# Access Compliance Report

## Public Rights-of-Way

### (Curb Ramps)

Intersection ID: 20314	Main Street: COLONY_RD	Cross Street: MORROCROFT_FARMS_LN	Location: S
ADA ID: 37D01FA98238	Ramp Type: Directional1	Initial Pass/Fail: Fail	Overall Compliance: No
		Severity Score: 1.25

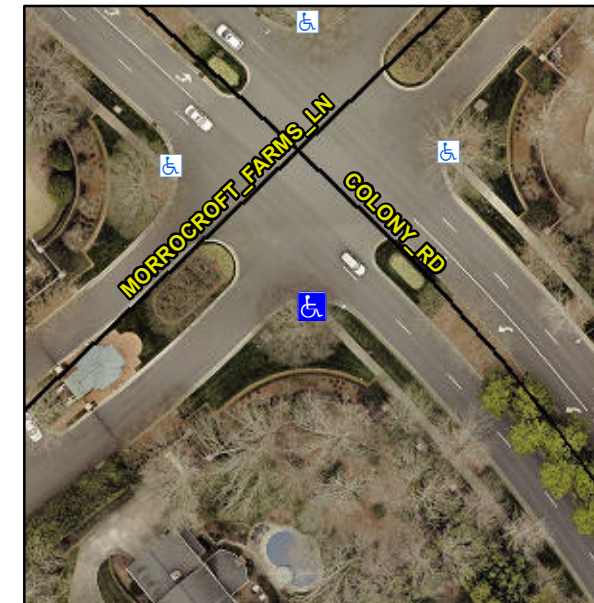
**R304.5.3**

Compliance	Description	Data	Compliance	Description	Data
N/A	Ramp Length (in)	65.0	N/A	Grade Break?	N/A
Yes	Ramp Width (in)	58.0	N/A	Grade Break Slope (%)	0.0
Yes	Ramp Slope (%)	5.4	N/A	Grade Break XSlope (%)	0.0
No	Ramp XSlope (%)	2.9			
N/A	Flare Type LT	N/A	N/A	Flare Type RT	N/A
N/A	Flare Slope LT (%)	N/A	N/A	Flare Slope RT (%)	0.0
N/A	Flare Traversable LT?	N/A	N/A	Flare Traversable RT?	N/A
N/A	Landing Length (in)	0.0	N/A	DWS Provided?	N/A
N/A	Landing Width (in)	0.0	N/A	DWS Contrast?	N/A
N/A	Landing Slope (%)	0.0	N/A	DWS Length (in)	N/A
N/A	Landing X Slope (%)	0.0	N/A	DWS Full Width?	N/A
N/A	Landing Curb? (Y/N)	N/A	N/A	DWS Offset LT (in)	N/A
N/A	Shared Landing?	N/A	N/A	DWS Offset RT (in)	N/A
N/A	Gutter Ponding?	0.0	N/A	Gutter Slope (%)	N/A
N/A	Gutter Lip Ht (in)	0.0	N/A	Gutter X Slope (%)	N/A
N/A	Painted X Walk1?	No		Road Slope (%)	2.4
	X Walk 1 Direction	To NW		Road X Slope (%)	0.9
	X Walk 1 Width (in)	N/A		Clear Space?	N/A

**Remove & Replace Entire Ramp.**
